MEETING LOG
DIRECTORATE FOR ENGINEERING SCIENCES

SUBJECT: Meeting of the Z21/CSA Lint Dust and Oil Working Group

Minutes of Meeting
of
Lint, Dust and Oil Working Group of the
Z21/CSA JOINT SUBCOMMITTEE ON STANDARDS
FOR GAS WATER HEATERS

- Item 1. Proposed Lint, Dust and Oil Test Protocol For Volume I Water Heaters**
[reconsideration in light of comments received on the November 2001 review and comment text]

Figure 14

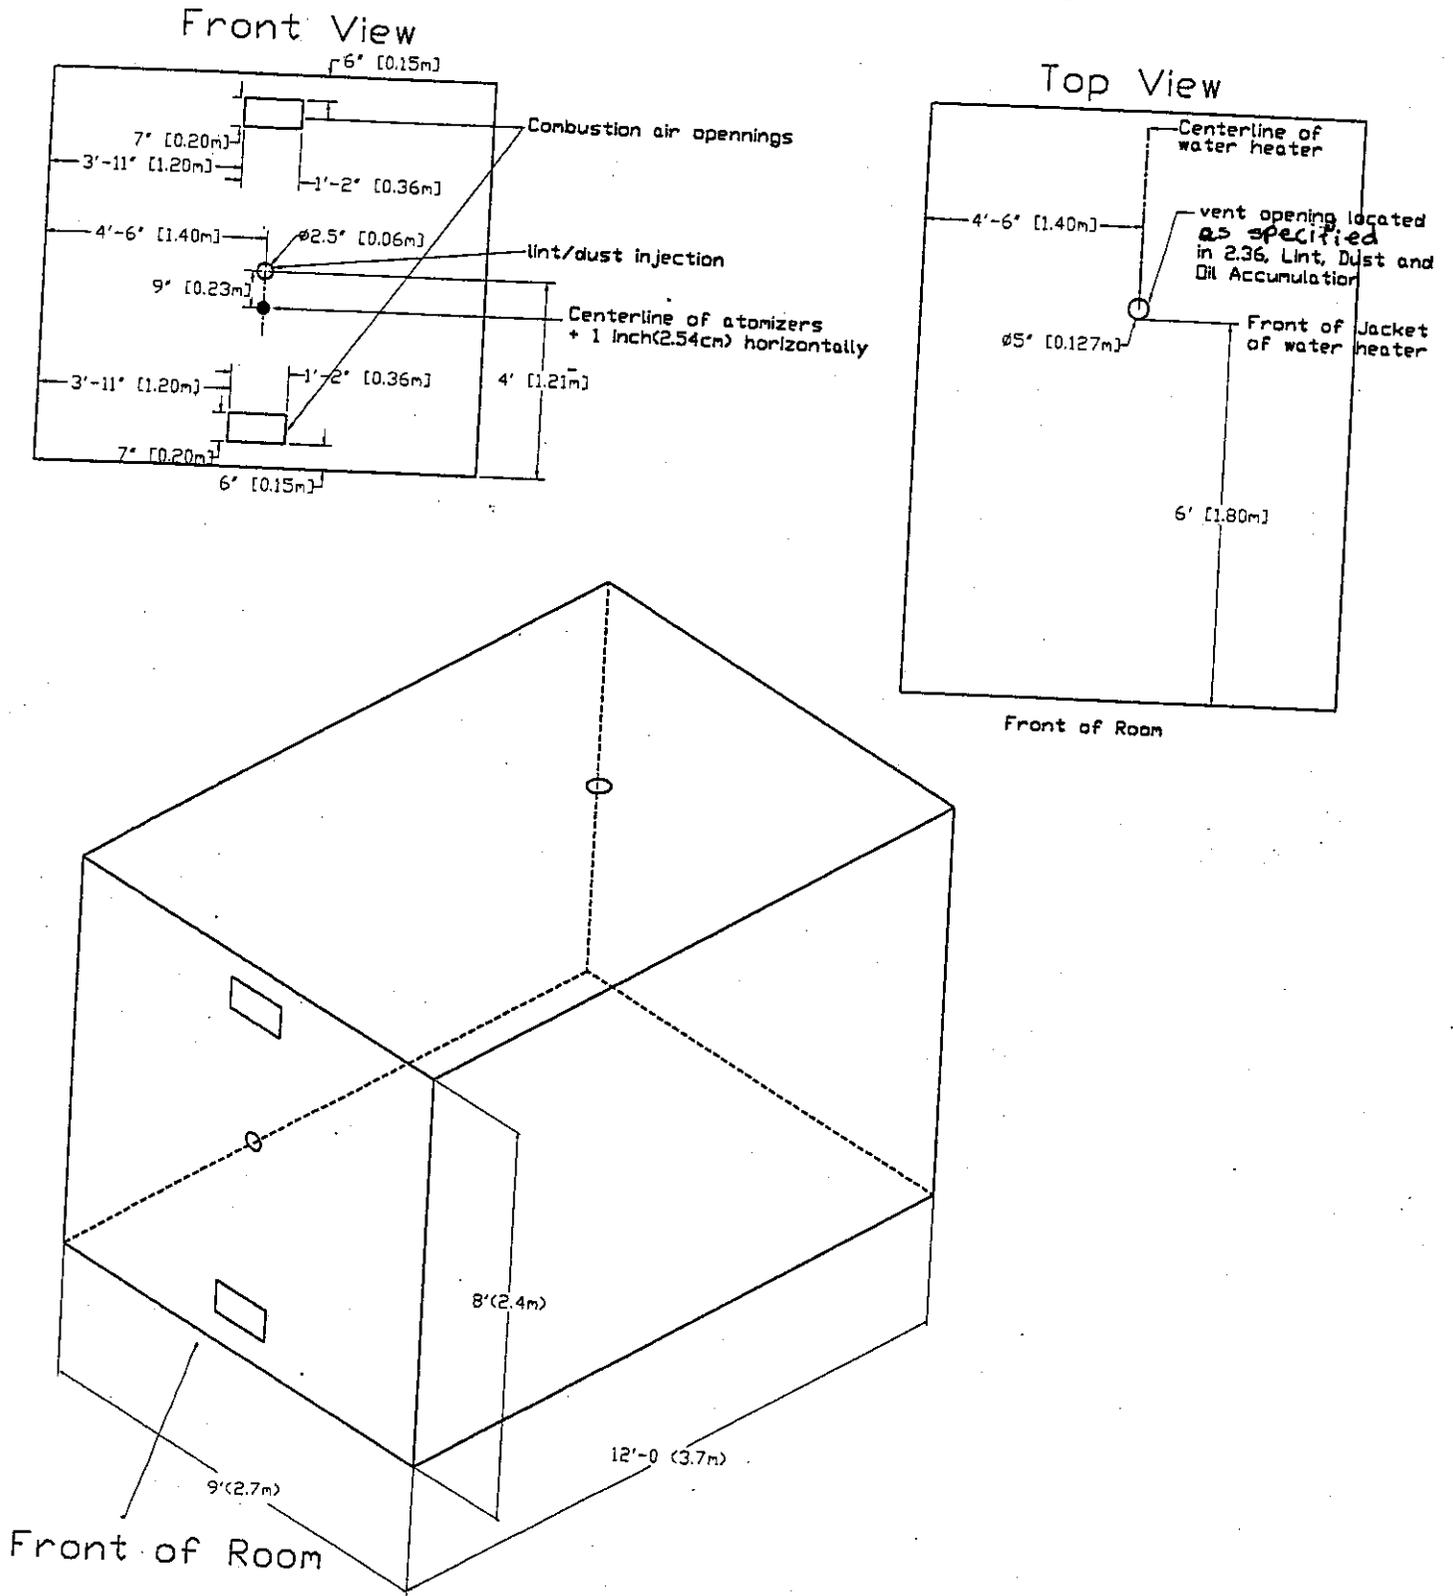
There are two holes in Figure XX for oil injection. Are there two spray guns?

During discussion, it was noted that the proposed drawing shows two openings. Further comment was made that if two nozzles are used, the standard should specify the injection rate because this could be handled with one nozzle/gun. Two manufacturers noted that they are currently conducting the test using only one nozzle. The joint subcommittee agreed that revising the test to specify a fixed horizontal line for atomizer openings would address this issue and eliminate any confusion or discrepancies of using one or more atomizer nozzles.

"The water heater shall be installed at the location specified in Figure XX." There is no water heater shown in Figure XX. Nor are there dimensions where the water heater is placed. This information should be added to Figure XX with a drawing of a gas water heater in the room.

On page 2, last paragraph, revise the first sentence to describe in detail the water heater "location", or revise the Figure XX to so indicate the water heater location. As the Figure XX exists now, only the location of the "vent opening" is indicated, not the location of the water heater. For a vertical exhaust venting water heater, the water heater may or may not be coaxial with the vent. For a horizontal exhaust venting water heater, the water will probably not be coaxial with the vertical section of the vent duct.

The drawing should include a water heater in the room with dimensions specified for the water heater location and orientation of the front of the water heater. Also, two holes are shown for oil injection. Is a single spray nozzle used or is it two?

1. Figure "xx" should be "14"
2. Add metric equivalents to all dimensions listed

The working group recommended subcommittee adoption of modifications of the "Front View" drawing in Figure 14 to specify the location of the atomizer opening on a fixed horizontal line as agreed to by the joint subcommittee at its December 12, 2001 meeting for submittal to the

Accept. The working group recommended subcommittee adoption of the proposed revisions to Figure 14 for submittal to the Z21/83 Committee and the CSA Technical Committee, as shown in Appendix A to these minutes.

Accept in Principal. Handled by previous action to revise figures to reflect heater location in the test room.

Detail "A"

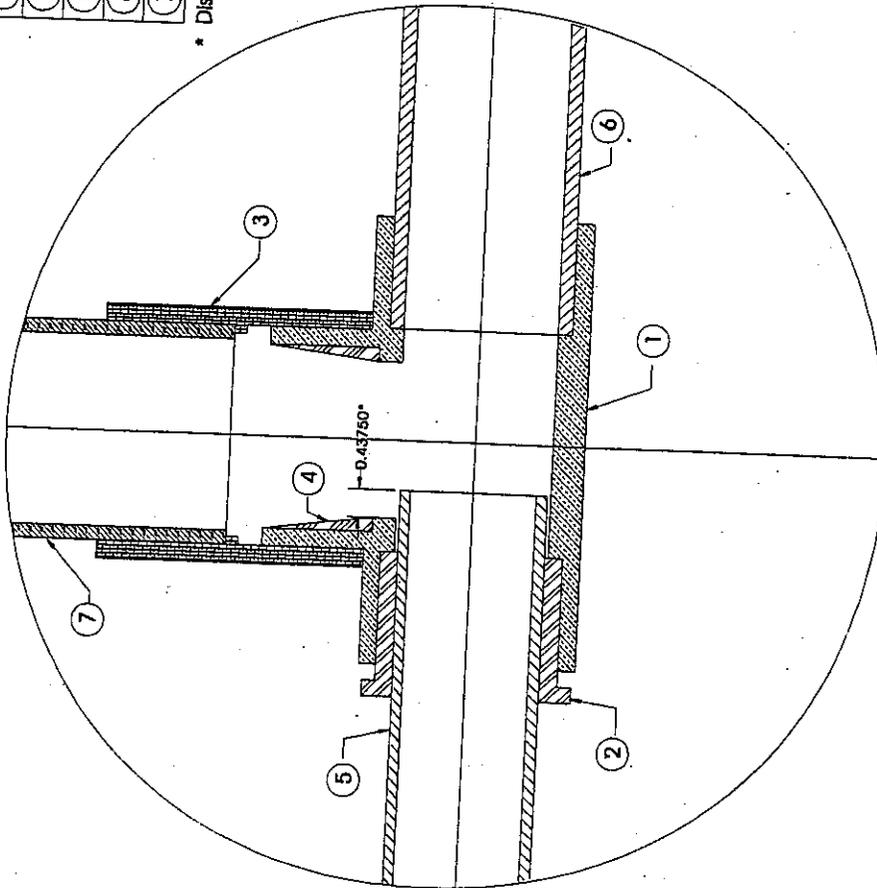
Change word "wye" to "tee" in all locations in these paragraphs

the word "wye" should be replaced with the word "tee" in all references in this section.
The actual part and drawing in Figure 8 reflect a tee not a wye.

AIR FILTRATION SYSTEM

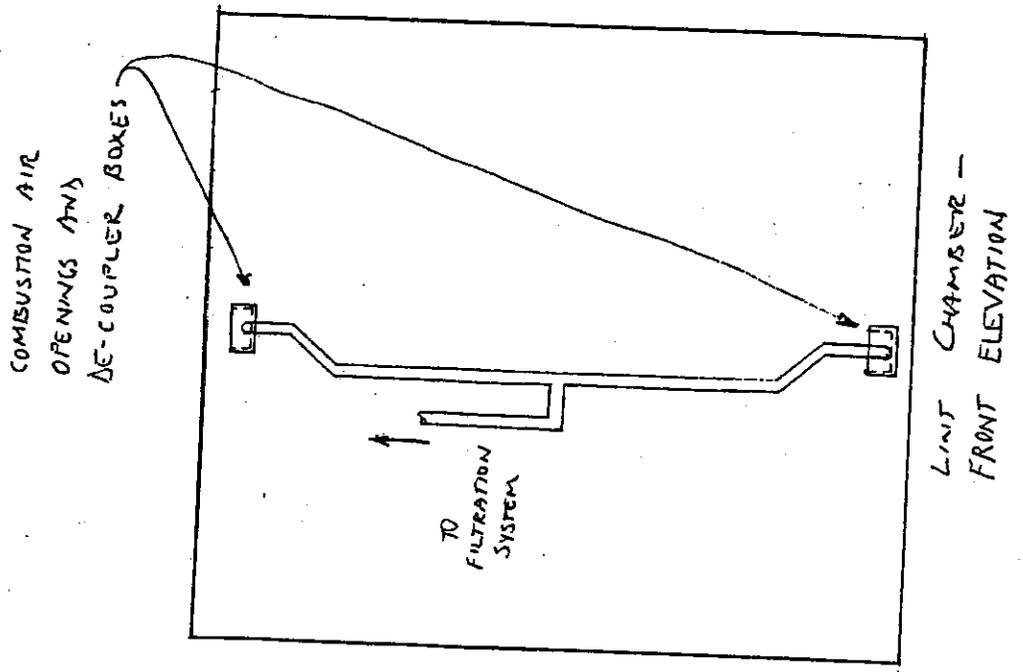
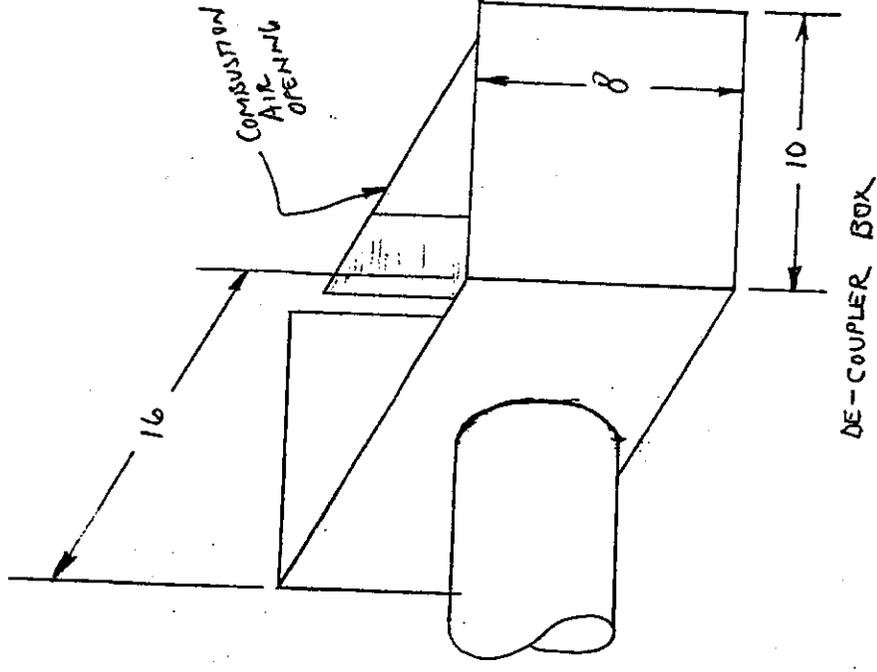
"Drawing #9" should be referred to as "Figure 9"

Ventilation System

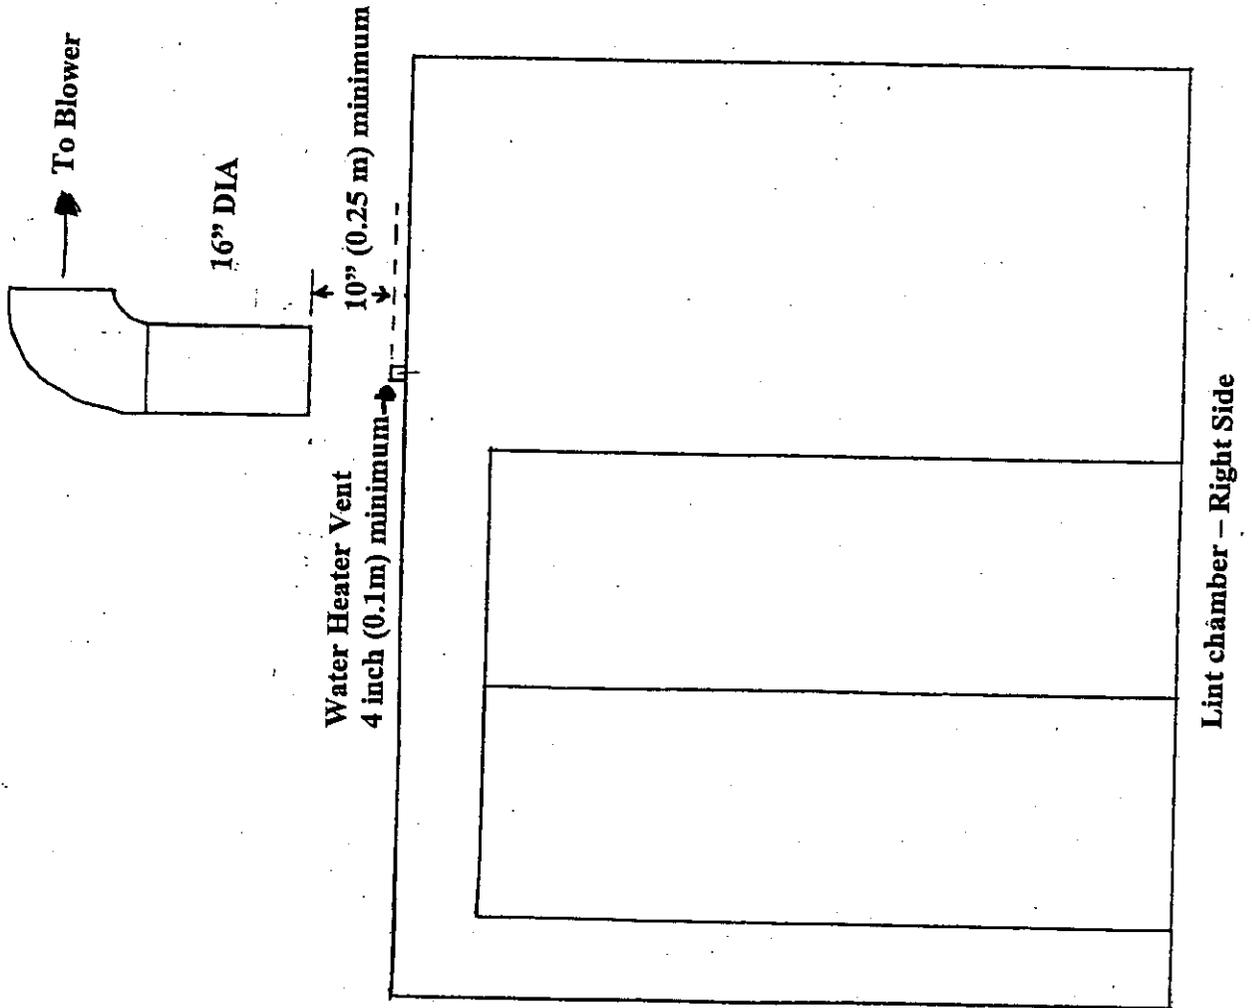
There should be a paragraph in Appendix G describing Figure 10 as the "Ventilation System". Suggested wording:

"Ventilation System: A ventilation system is used to vent the flue products of the water heater. A decoupling spacing of 14 inches from the top of the room is intended to allow air pressure balancing within the test room during water heater operation. Figure 10" Also, the amount of vent pipe protruding through the ceiling of the test room should be specified as "4 inches" on Figure 10.

Accept. The working group recommended subcommittee adoption of this editorial revision to revise Figure 10 of Appendix G to specify a 4 inch minimum dimension for the water heater vent outlet and a 10 inch minimum distance from the water heater vent outlet to the vent pipe inlet for submittal to the Z21/83 Committee and the CSA Technical Committee, as shown in Appendix A to these minutes. The working group noted that this revision is consistent with current practice.
